BHPL Designers Responses to RSA Recommendations - 31.10.25

Comments made in order raised withing Audit. Key plan showing location of each comment is given below (extract from Appendix 3 of the RSA).

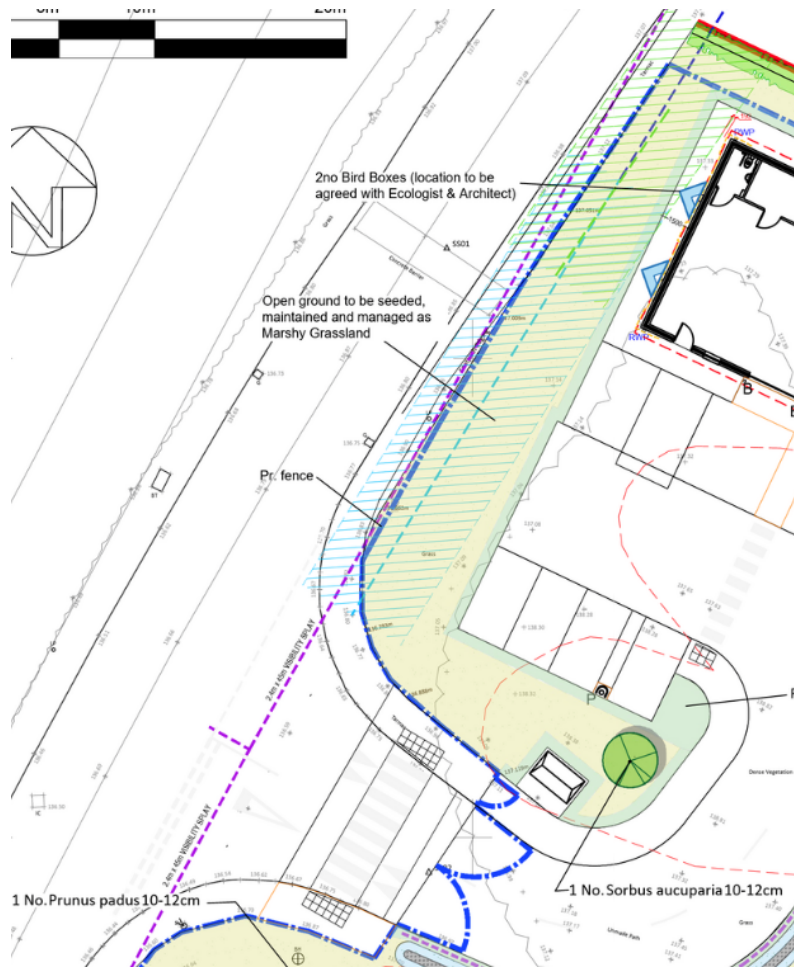
2	Items raised at this Stage 1/2 Audit	
2.1	Local alignment	
	Landscaping	
2.1.1	Summary Visibility for pedestrians waiting to cross the road (looking towards the main road) crosses the landscaping/planting areas at the back-edge of the footway on both sides of the carriageway and could be obstructed as the planting matures. Location Tactile paving at either end of the crossing across the site access It is noted from the plans provided that the visibility for pedestrians waiting to cross the road (looking towards the main road) crosses the landscaping areas at the back-edge of the footway on both sides of the carriageway. As the planting/landscaping matures, this could obstruct visibility for pedestrians and could lead to pedestrians stepping into the carriageway injudiciously, when it is unsafe to do so, increasing the potential for a pedestrian to be hit by a passing vehicle. Recommendation It is recommended that low level planting is specified within the visibility splays, and that regular maintenance is undertaken to ensure the landscaping/planting does not grow beyond 650mm in height.

Designers’ Response: 2.1.1 Soft landscaping has been designed to be low level marshy grassland which is to be maintained in the future by NPTC; see extract from Landscape Architects’ design proposals given below in confirmation.

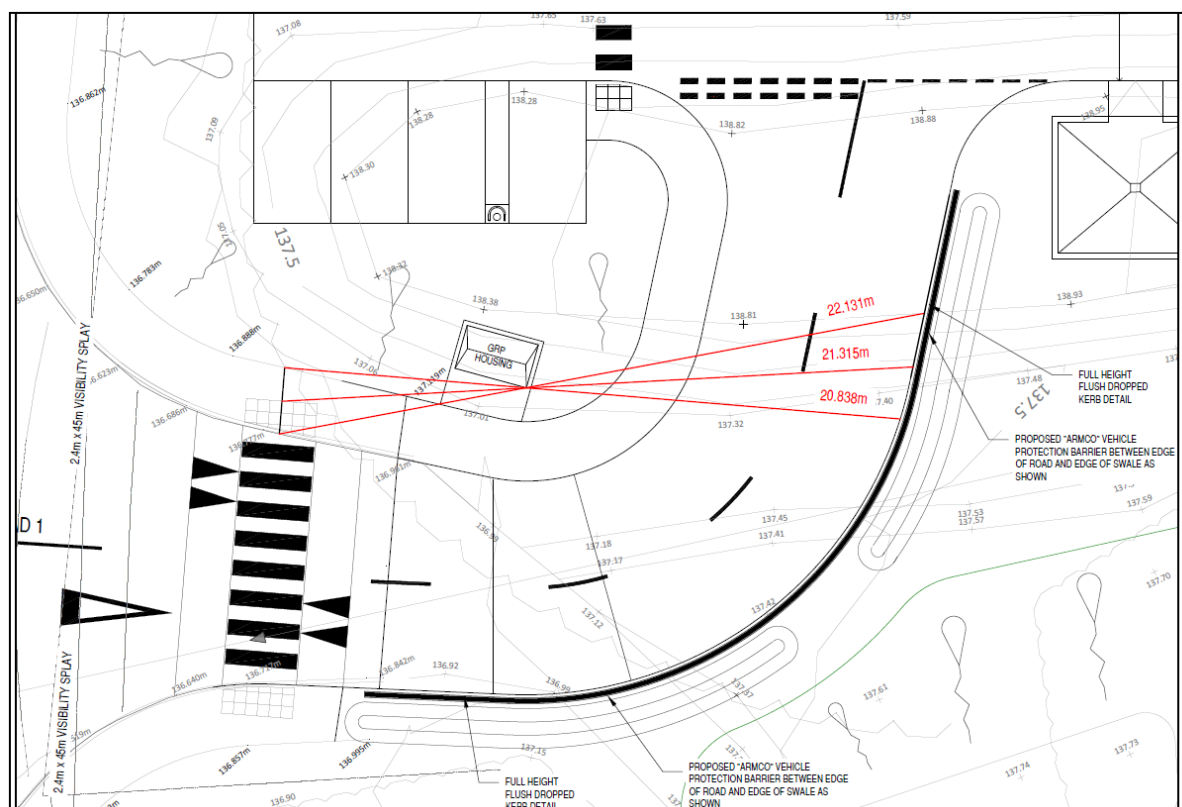
2.4 Walking, cycling and horse-riding	
Pedestrians	
2.4.1 Summary In the absence of any specific details, it is difficult to determine whether the proposed electricity sub-station sits within the visibility splay for pedestrians (travelling north to south) waiting to cross the road. Location Proposed crossing across the access	
It is noted from the plans provided that it is proposed to provide a structure (possibly electricity sub-station) to the north of the footway on the northern edge of the access into the site. In the absence of any specific information, it is difficult to determine whether the structure sits within the visibility splay for pedestrians (travelling north to south) waiting to cross the road. Insufficient visibility could lead to pedestrians stepping into the carriageway injudiciously, when it is unsafe to do so, increasing the potential for a pedestrian to be hit by a passing vehicle. Recommendation It is recommended that the required visibility, based on the posted speed limit, is determined and plotted and, if necessary, site the proposed structure outside of the visibility splay.

Designers Response 2.4.1 – see below for constructed forward visibility splays for pedestrians and cyclists stopping at northern end of crossing point. DOT Local Transport Note 1/20 gives recommendations on visibility splays, Section 5.8 “Visibility Splays” and Table 5-5 gives forward lines for various speed limits. For 30mph the Y dimension = 31m and for 20mph = 17m. Arguably the new minor access road is 20mph and therefore the minimum distance of 20.7m is deemed acceptable.

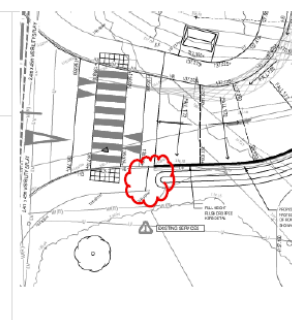
2.4.2	Summary The proposed footway on the southern side of the access terminates immediately east of the proposed crossing, and there is nothing to indicate to blind or partially sighted pedestrians that the footway terminates. Location Footway along the southern edge of the access road.
	It is noted from the plans provided that the footway along the southern edge of the access road terminates immediately east. However, there is nothing to indicate to blind or partially sighted pedestrians that the footway terminates. This could lead to confusion for blind/partially sighted pedestrians and could result in pedestrians stepping into the carriageway injudiciously, away from the crossing, when it is unsafe to do so, into the path of passing vehicles, or could result in pedestrians stepping in to the swale. Recommendation It is recommended that the appropriate tactile paving is provided before the end of the footway together with planting to prevent pedestrians from entering the swale.

Designers' Response 2.4.2 – Buff Blister paving will be installed as per data sheet below, size 400x400mm.
